**REQUEST FOR EXCEPTION TO
RAPID CITY DESIGN STANDARD / CRITERIA / REGULATIONS**

PROJECT Highpointe Ranch

Re: Request to waive the requirements to install a 26' wide paved surface, curb, gutter, sidewalk, street light conduit, water and sewer in the Section Line Right-of-Way along the Eastern Boundary of the Property.
Associated with Highpointe Ranch Subdivision
City File # 17EX031, Associated Files 16PL103

RE: Request for Exception to Rapid City Design Criteria
Highpointe Ranch Subdivision – Section Line Right-of-Way
KTM Project No. 16-0817
RC Project No. 16PL103

EXHIBIT A
MAJOR STREET PLAN

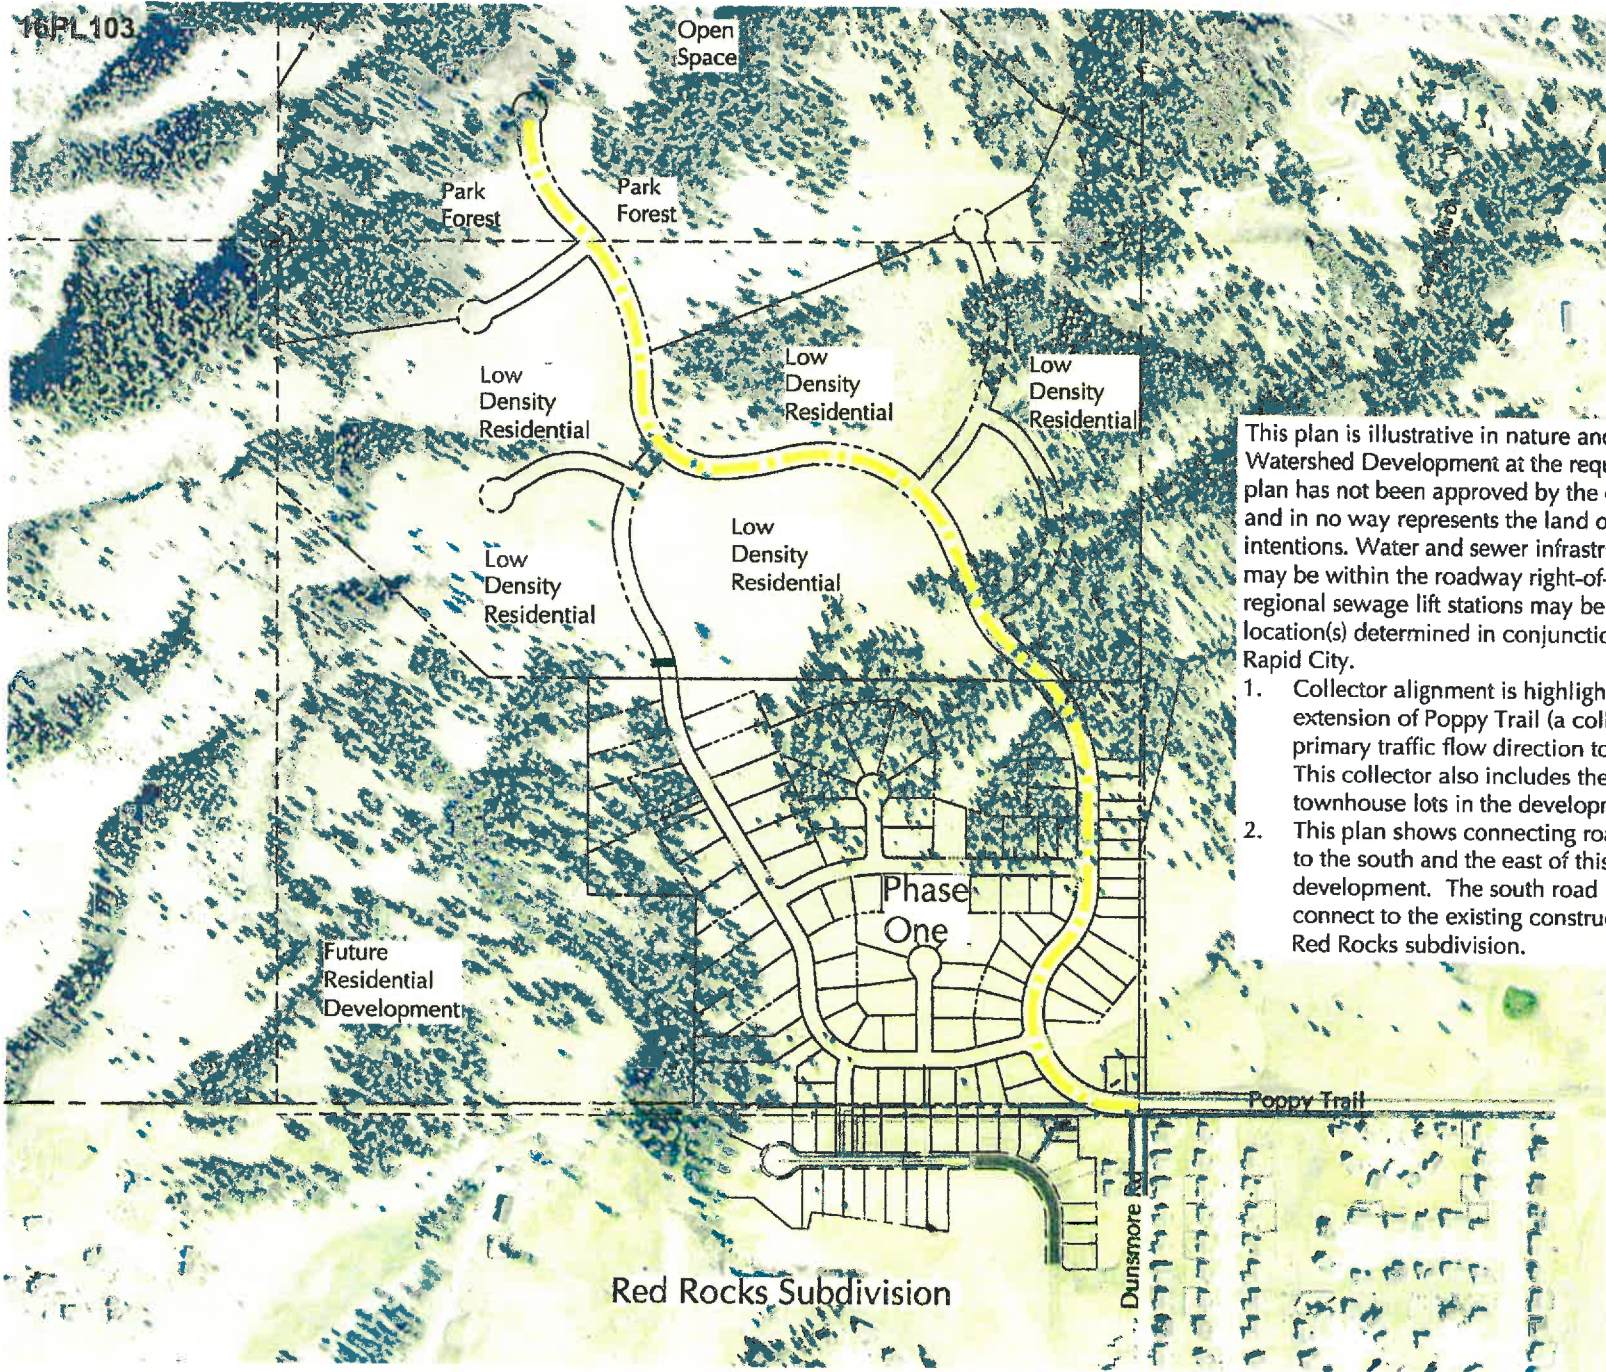
1. The Major Street Plan as adopted by the city of Rapid City (See attached Exhibit A) identifies the continuation of Poppy Trail as a Collector street. The construction of the section line road would interfere with the operation of the collector street and provide redundant street networking.

Sheet Title: **Master Plan**

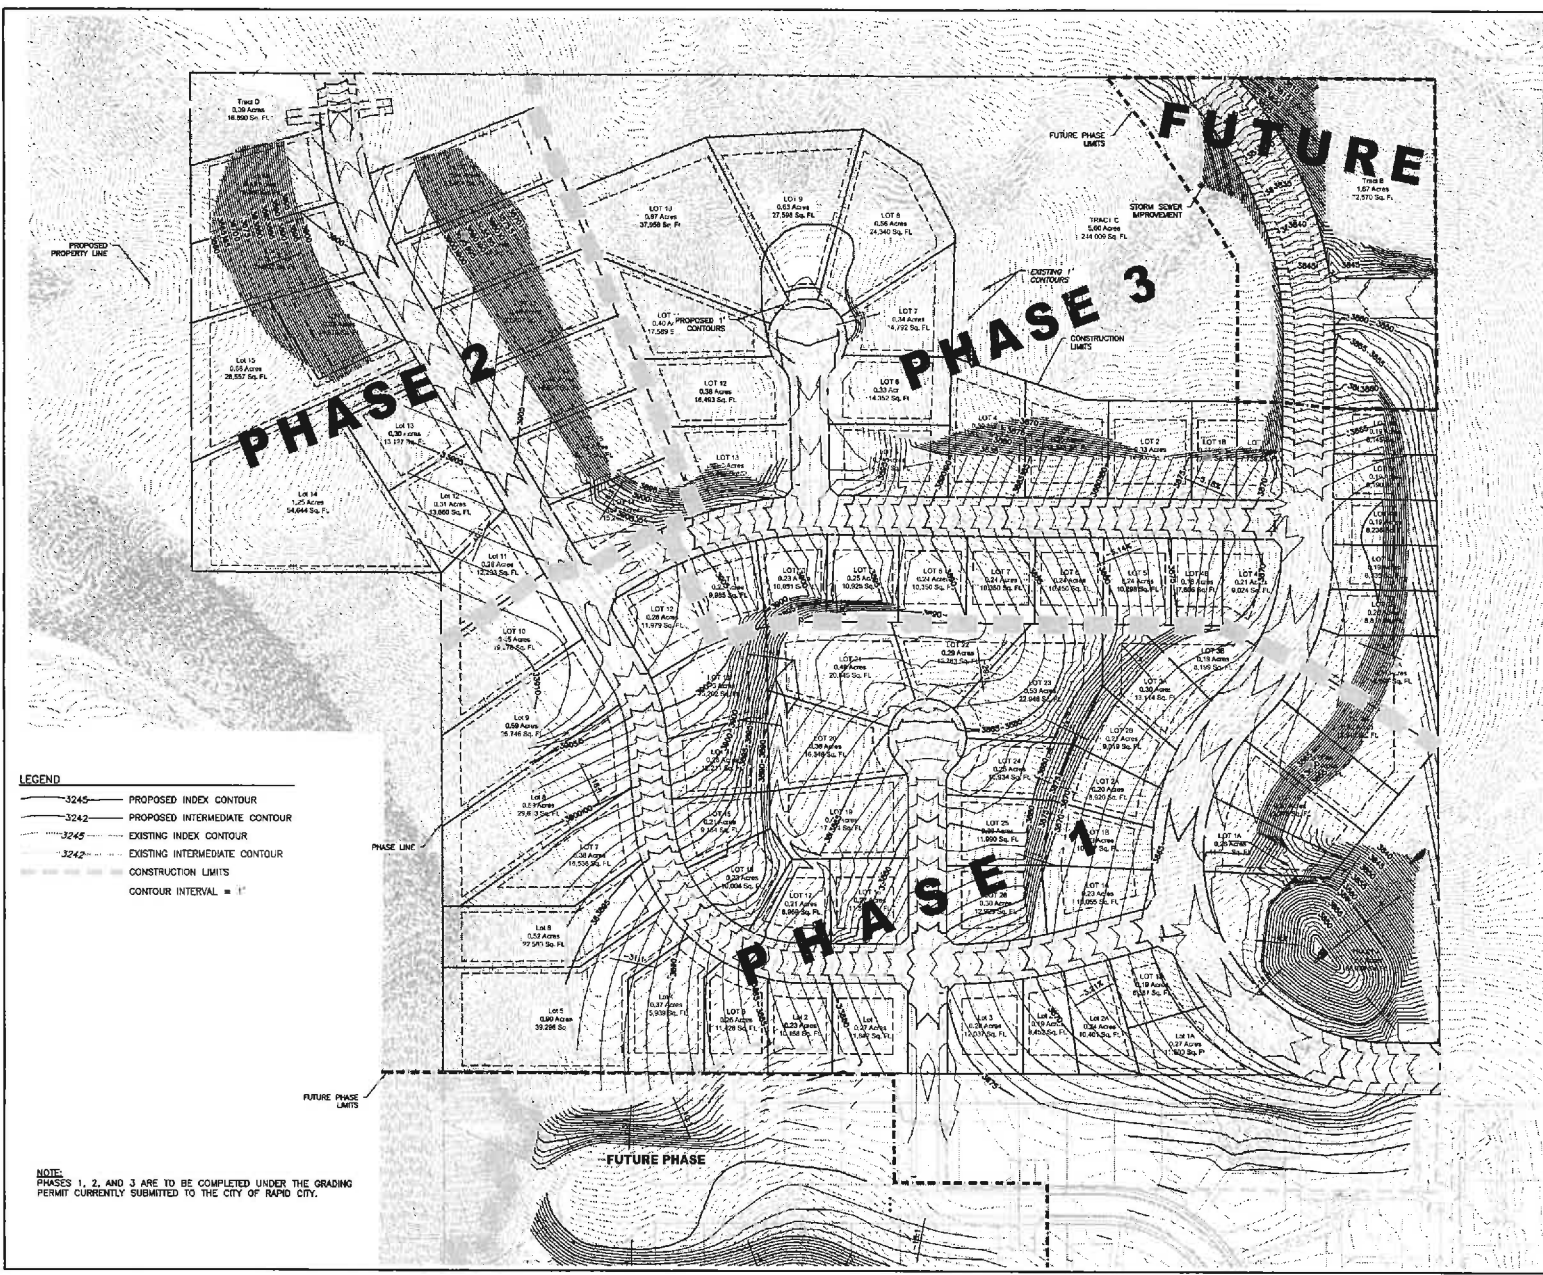
4. In lieu of the section line road additional street, road and utility networks are proposed to provide access and utility service to this development and adjoining properties in accordance with the Major Street Plan (see attached master plan) and IDCM.
